Regional Municipality of Durham

Bid Opportunity: T-1034-2026 - General Contractor for the construction of 409 Centre Street South in Whitby

Addendum number 6 – November 2, 2026

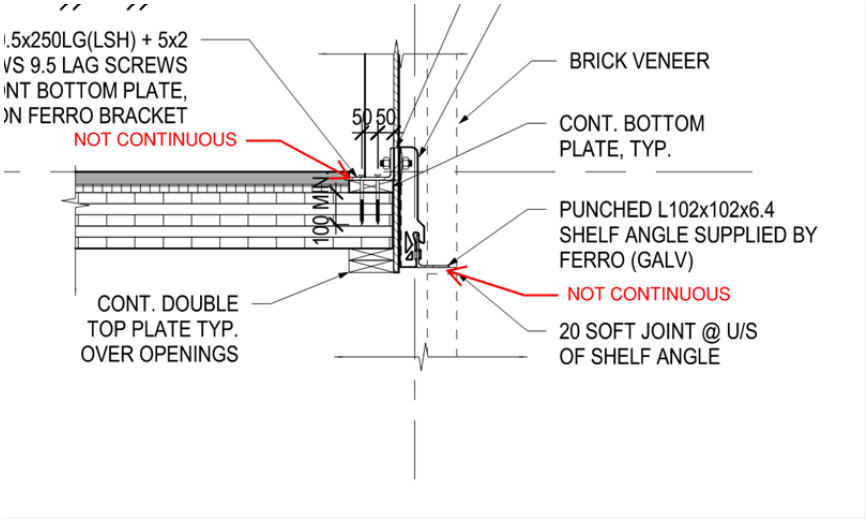
Please refer to Q/A#25 from Add#4, continuous Shelf angle per section at the openings 2/S510 L102x102x6.4. Response was that the angle screwed to the CLT deck is not continuous. However, section detail 1/S510 along grid line 2 shows angle. Please confirm and provide extent of angle on plan.

I marked up the below section to make clear which angle is and is not continuous
